SUBJECT L.C. Kelly No. 5

Re: Plug Back

Well: 5 L. C. Kelly

CONDITIONS OF APPROVAL

L C KELLY #5 LOCATION, 03 30N 12W COMMINGLE DK GP ORIGINAL COMPLETION 12/64 LAST FILE UPDATE 5/93 BY CSW

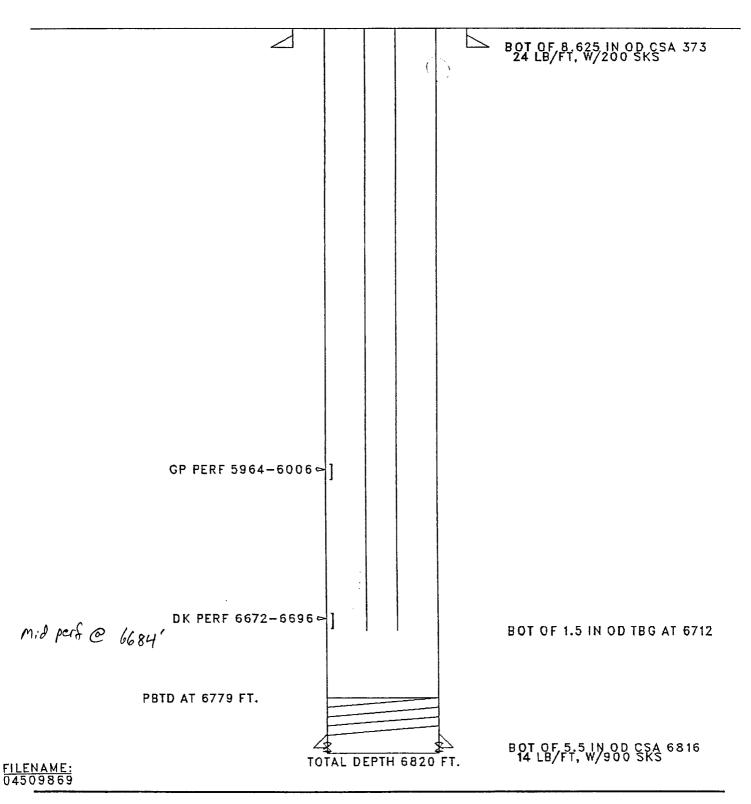
1.) Top of Dakota 2 6614' - Putorations 6672-6696'

Spot a cement plug from the top of the Vetainie 2 6622' to 6564'

2.) Top of Gallup 2 5749' - Perforations 5964'-6006'

Spot a cement plug from the top of the

Vetaine 2 5914' to 5699'
